**Committee of Experts on the Transport of Dangerous Goods
and on the Globally Harmonized System of Classification
and Labelling of Chemicals**

**Manual of Tests and Criteria, review of Test Series H:
determination of self-accelerating decomposition
temperature**

Transmitted by the Chairman of the Working Group on Explosives

1. This document provides a marked-up copy of Section 28 of the Manual of Tests and Criteria, with the amendments proposed in document ST/SG/AC.10/C.3/2020/3-ST/SG/AC.10/C.4/2020/4.
2. All changes are indicated: inserted text is shown in **red** and deleted text in **~~red~~, strikethrough**.
3. The TDG and GHS sub-committees are invited to consider the proposed amendments for adoption.

Figure 28.4.2.1: Adiabatic storage test

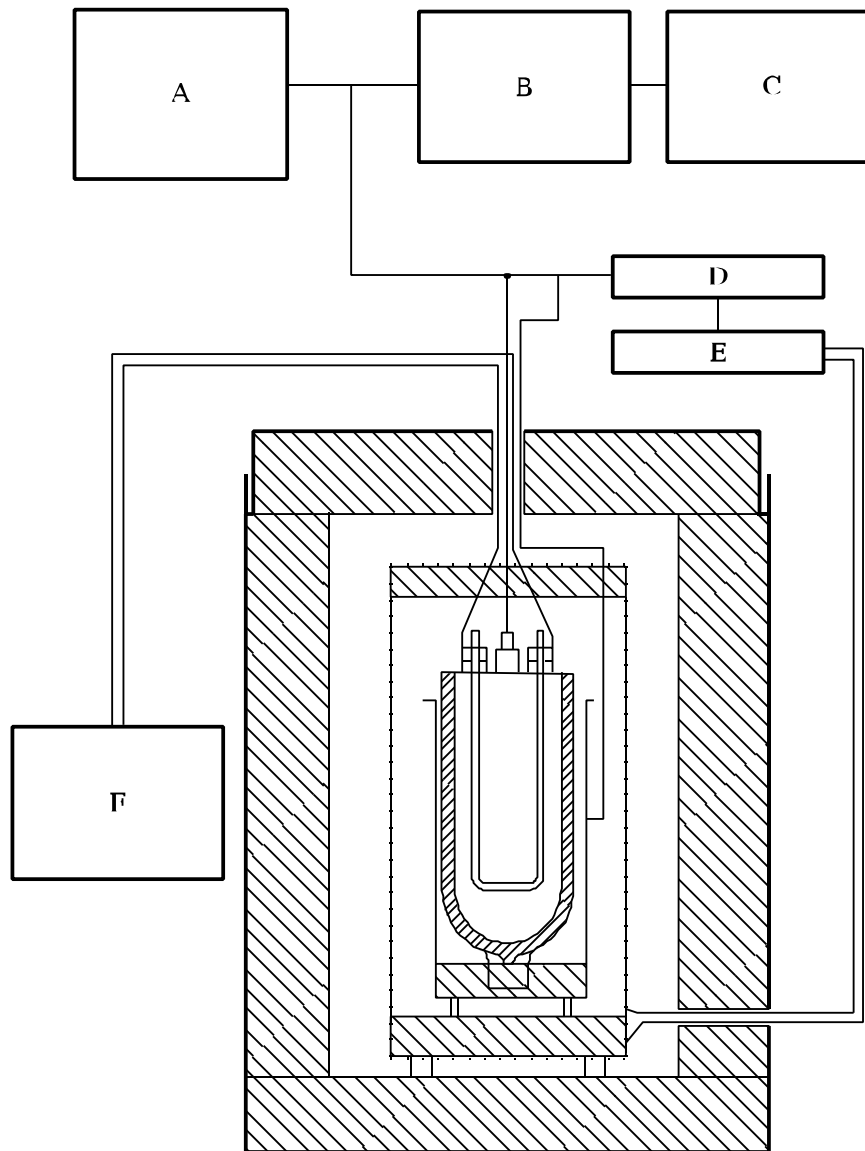
The apparatus consists of a glass Dewar vessel (~~max. 31.0 or 1.5~~ litre) to contain the sample, an insulated oven with a differential control system to keep the temperature in the oven to within 0.1 °C of the sample temperature, and an inert lid for the Dewar vessel. In special cases, sample holders of other construction materials may have to be used. An inert heating coil and cooling tube pass through the lid into the sample. Pressure build-up in the Dewar vessel is prevented by ~~a 2-m long PTFE~~ sufficiently long capillary tube ~~made of an inert substance (e.g. 2 m long PTFE tube) which passes~~ through the insulated lid. A constant power heating unit is used for internal heating of the substance to a ~~pre-set~~ temperature or for calibration. Internal heating and cooling may be stopped or started automatically at ~~pre-set~~ temperatures. In addition to the cooling system, a secondary safety device is ~~used to fitted which~~ disconnects the power supply to the oven at a ~~pre-set~~ temperature. A schematic drawing of ~~the an open apparatus for the adiabatic storage test AST~~ is given in Figure 28.4.2.1.

Figure 28.4.2.2: Example of determination of SADT or SAPT

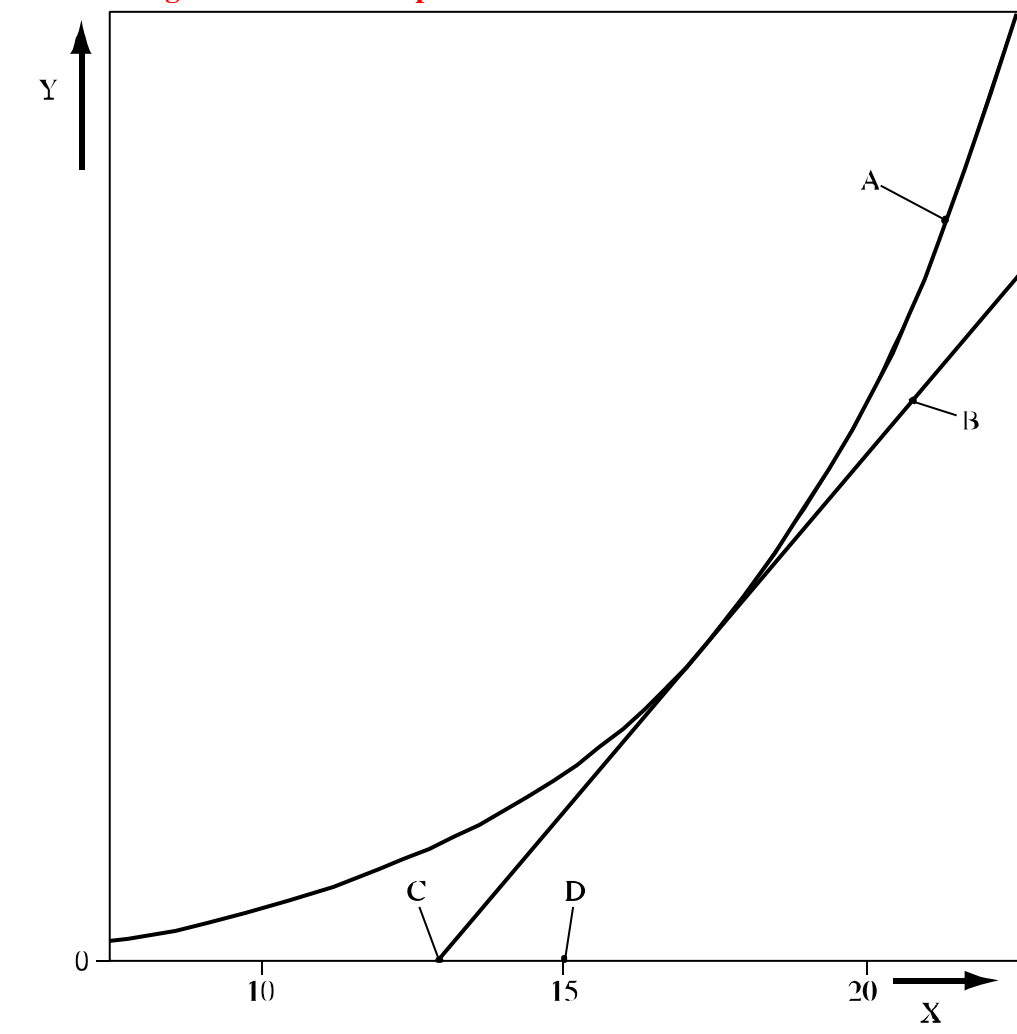
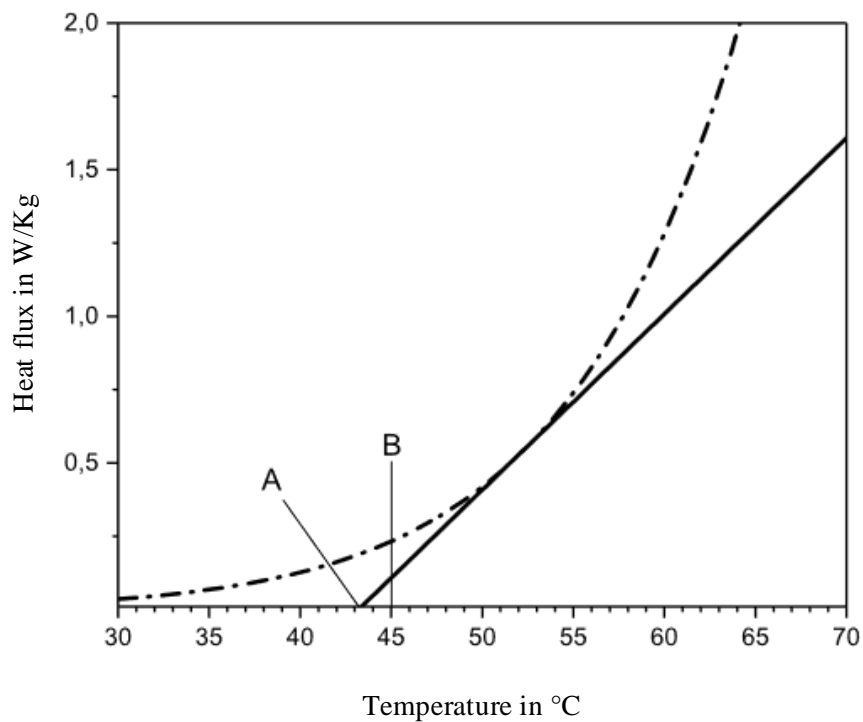
28.4.2.4.6 Plot the calculated rates of heat generation per unit of mass (Q_T) as a function of the temperature in a graph with linear scales and draw the best-fit curve through the plotted points. Determine the heat losses per unit of mass, L ($\text{W}/\text{kg}\cdot^{\circ}\text{C}$) of the specific package, IBC or tank (see 28.3.5). Draw a straight line of gradient L tangential to the heat generation curve. The intersection of the straight line and the abscissa is the critical ambient temperature, i.e. the highest temperature at which the substance as packaged does not show self-accelerating decomposition. The SADT is the critical ambient temperature ($^{\circ}\text{C}$) rounded to the next higher multiple of 5°C . An example is given in Figure 28.4.2.2.

Figure 28.4.3.2: Example of determination of SADT or SAPT

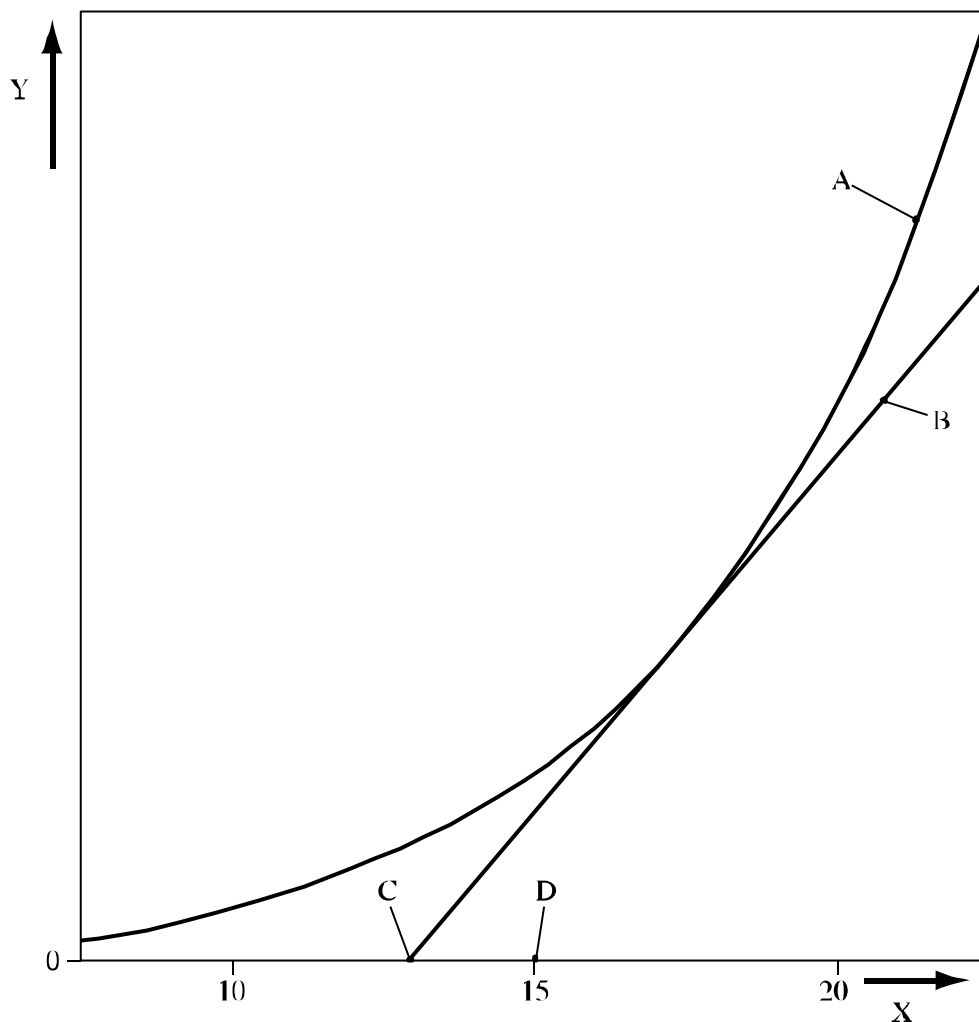
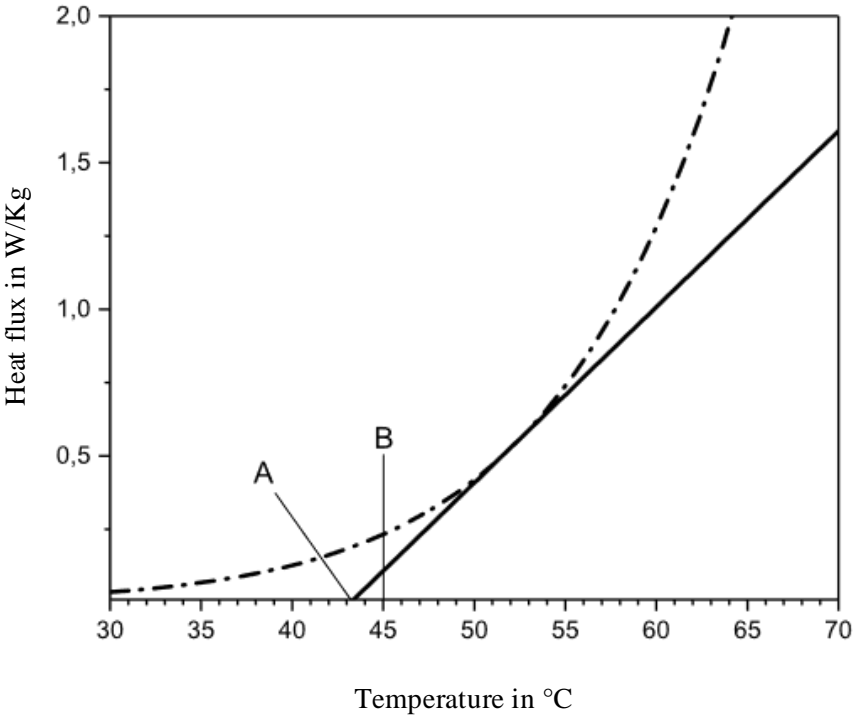
28.4.3.4.13 Plot the calculated maximum rate of heat generation per unit of mass as a function of the test temperature on a graph with linear scales and draw the best-fit curve through the plotted points. Determine the heat losses per unit of mass, L (W/kg.°C) of the specific package, IBC or tank (see 28.3.5). Draw a straight line of gradient L tangential to the heat generation curve. The intersection of the straight line and the abscissa is the critical ambient temperature i.e. the highest temperature at which the substance as packaged does not show self-accelerating decomposition. The SADT or SAPT is the critical ambient temperature (°C) rounded to the next higher multiple of 5 °C. An example is given in Figure 28.4.3.2.
